Seiden, 49 Croton Dam Road, Ossining
Requested Amendments to Previous ARB Approvals
7/21/2021

Garage Addition

Request for 2nd floor over hallway to garage recreation room

Current Brick Façade

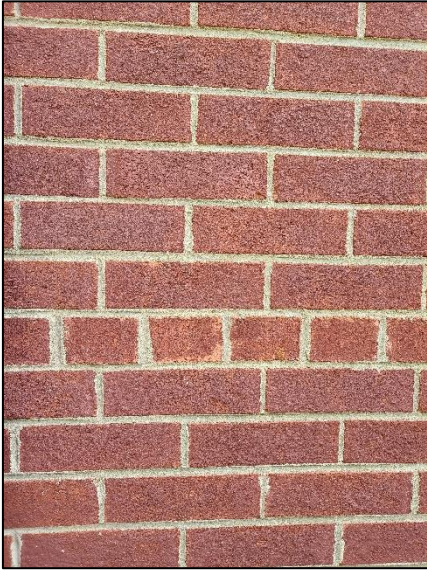
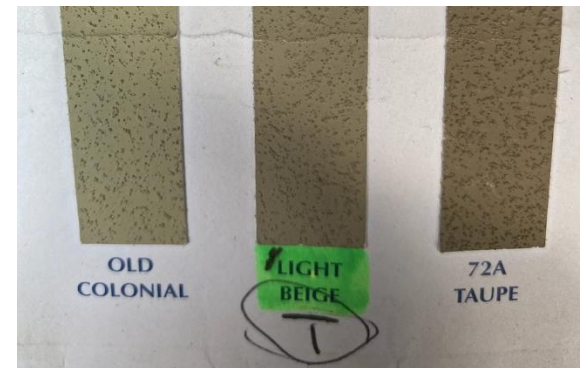
- a. **Brick** on (garage) front and (patio) left elevations of home. These are the areas in full view every day. **Took 3 months** but found identical brick color and mortar.

Original Brick

New Brick

Matching Mortar

Second Floor Hallway Request w/Window Views

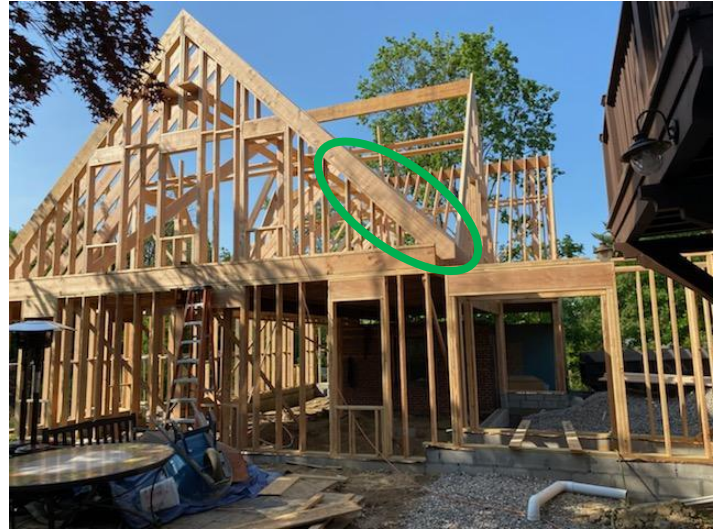
Requesting to add 2nd floor onto hallway from main house to garage/recreation room structure

*Windows circled will be relocated to exact areas onto hallways.

*Window on 2nd floor area opened up as doorway to create access to 2nd floor hallway.

Roof area circled will be where 2nd floor hallway will connect to garage structure.

Roof area circled will be where 2nd floor hallway will connect to 2nd floor garage structure.

Second Floor Hallway Request w/Window Views

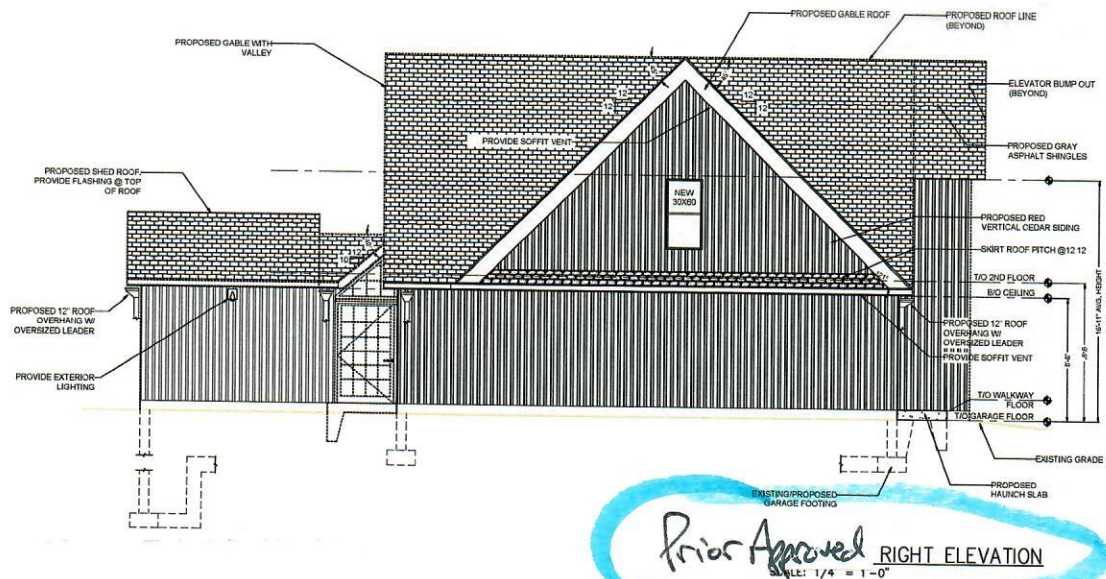
2nd floor: Current view from pre-existing window towards neighbor Picucci, 51 Croton Dam Rd. This window will be relocated from “bedroom to hallway” to exact same viewing area.

2nd floor: New view from New window towards neighbor Rinaldi, 45 Croton Dam Rd. Totally obstructed view, overlooking at own property's Shed Bar and trees.

Adding
TWO
window
locations

2nd floor: New view from New window towards neighbor Picucci, 51 Croton Dam Rd. Obstructed view, partially looking at own new garage, partially overlooking neighbor's detached garage.

PROPOSED RECREATION LEVEL PLAN
 SCALE: 1/4" = 1'-0"

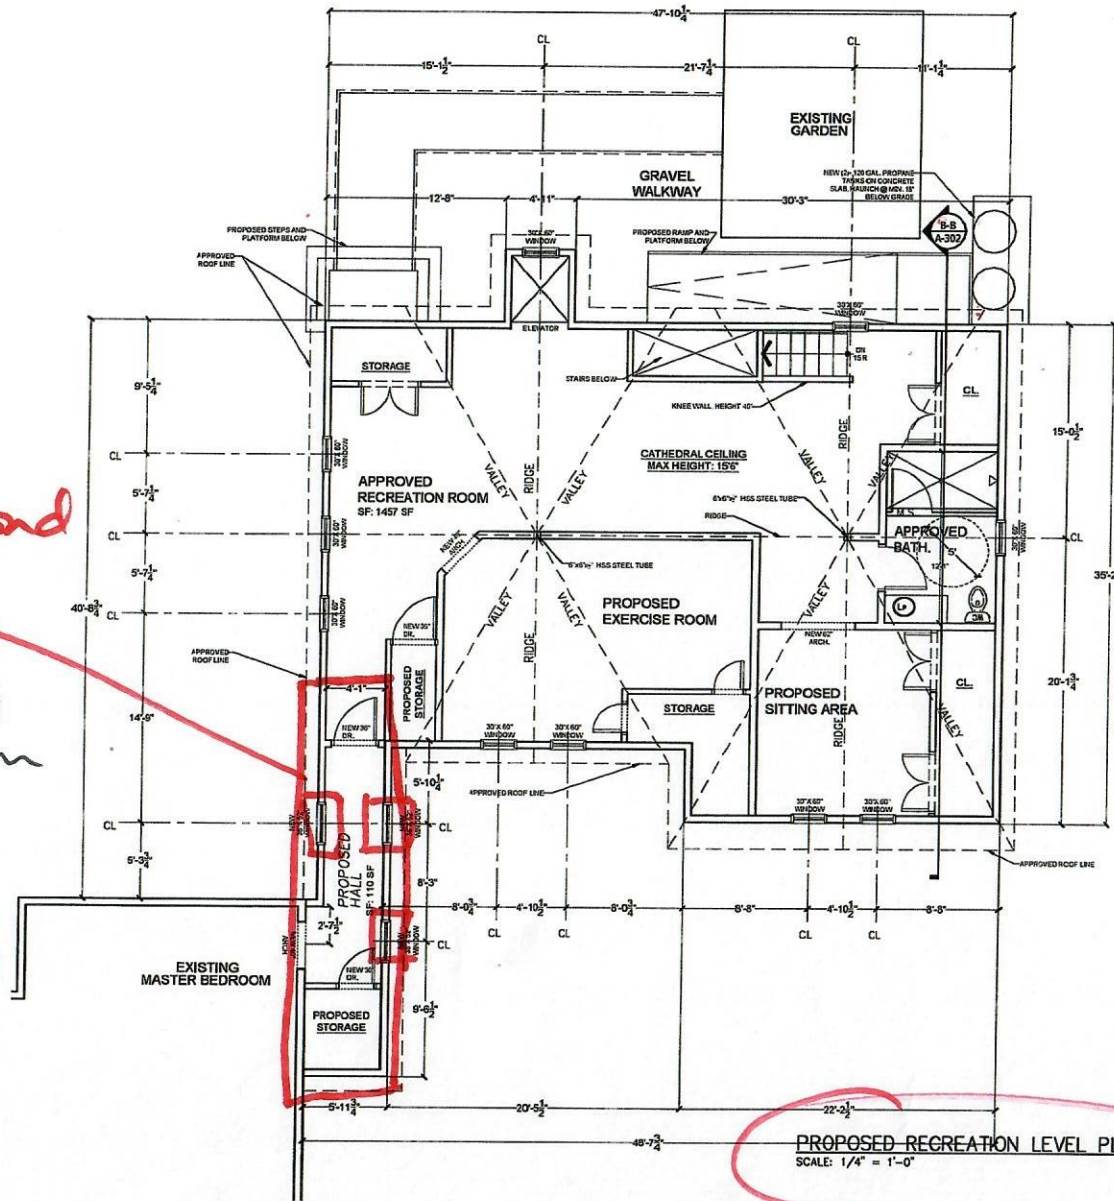
Proposed Second floor hallway
 ① Proposed 3 windows
 (recycled from current home and original garage)

PROPOSED FRONT ELEVATION
 SCALE: 1/4" = 1'-0"

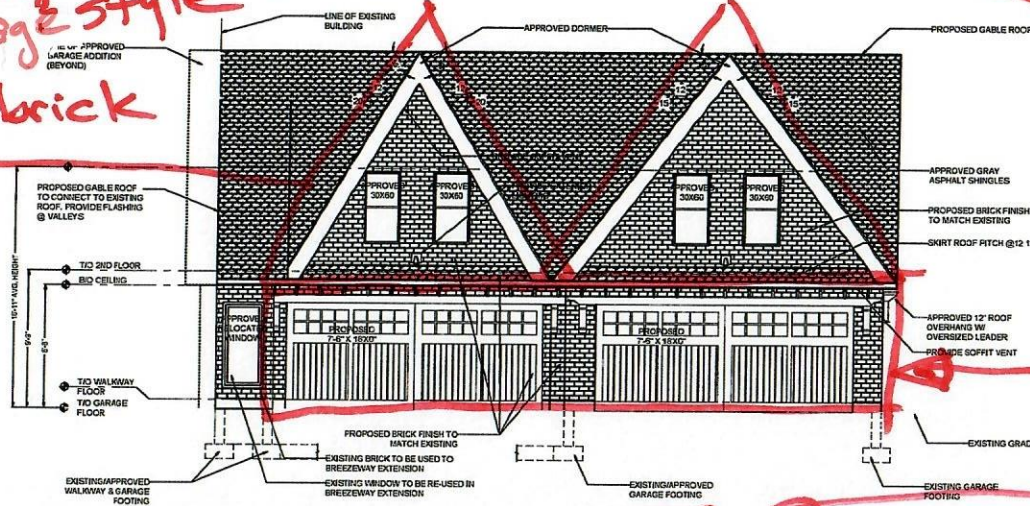
Proposed
 ① Barn style garage doors to carriage style

② Facade to be brick to match brick of current structure

PROPOSED REAR ELEVATION
 SCALE: 1/4" = 1'-0"

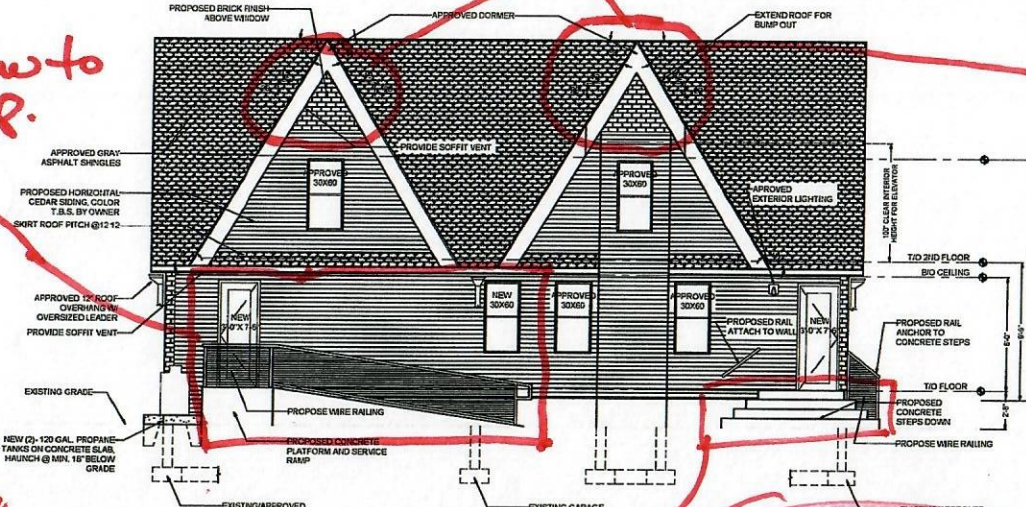
Proposed
 ① changing window to door with ramp.

② Relocating window to be next to approved window

③ wider stairs

④ Brick over windows in gable - rest of rear facade - horizontal cedar siding

PROPOSED LEFT ELEVATION (PATIO SIDE)

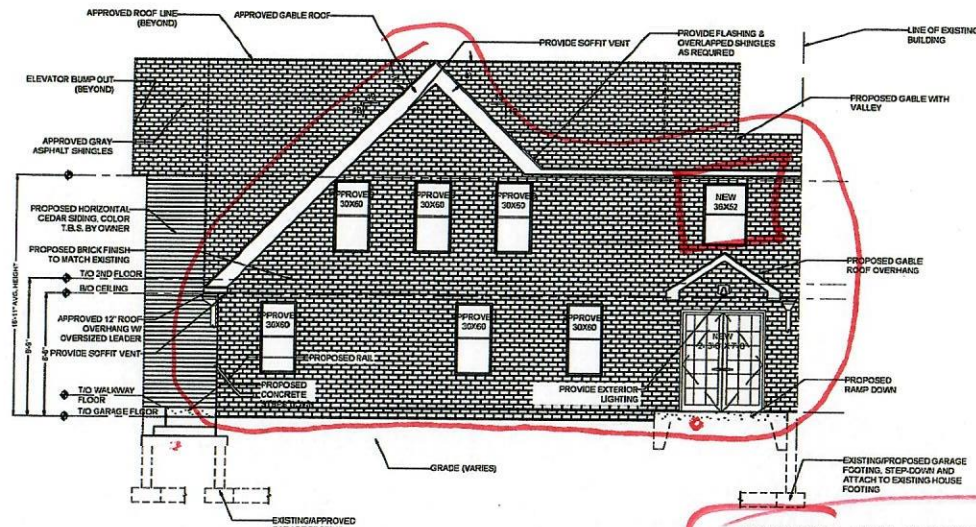
- Proposed
- 1.) Add window
 - 2.) Brick facade to match brick of current structure

PROPOSED RIGHT ELEVATION

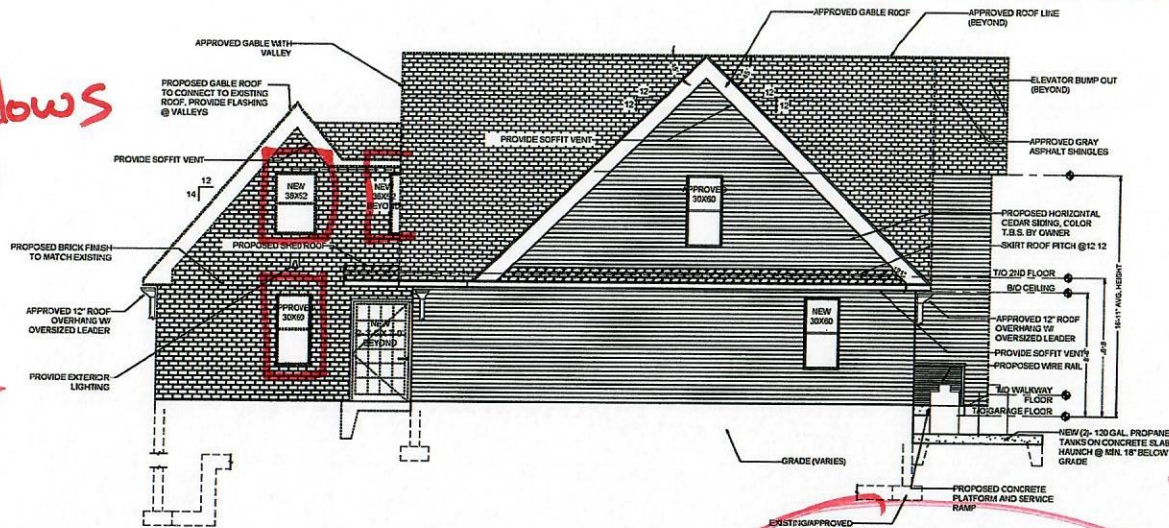
- Proposed
- 1.) Add 3 windows
 - 2.) Brick facade of extended original part of house to match current structure
